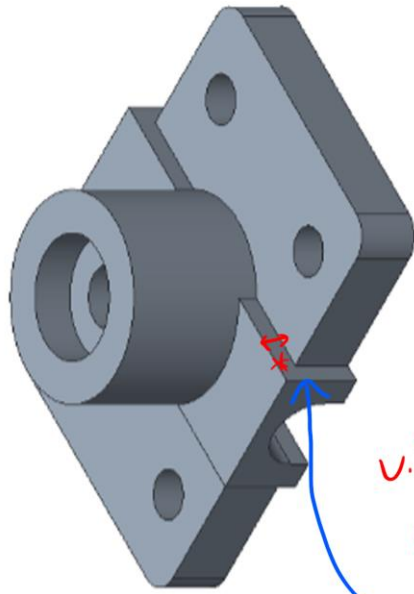
- (1) The 8.27 dimension on top right doesn't match with 11 dimension on bottom right.

- (2) The size of the hole on bottom right is given as a radius curve, not a diameter circle.

- (3) The 84.53 dimension on bottom left adds confusion and is not the correct way of measuring that surface.

- (4) The 110.39 dimension on the bottom right, while not being incorrect, should be a different dimension that gives the same information in a more readable way.

- (5) The 35(?) dimension and 98(?) dimension on the top left are overlapping and difficult to read, hence the (?).

- (1) Remove the 8.27 dimension as based on visual cues and comparing with other dimensions it is incorrect and 11 is correct.

- (2) Change the dimension to a diameter (i.e. $\varnothing 38$).

- (3) Remove the dimension as we already have enough information from top left to create that portion of the drawing.

- (4) Remove the dimension and add a dimension to the bottom left of the bottom left drawing for how high the vertical segment should be before the chamfer.

- (5) Move the dimension text to make it more readable.
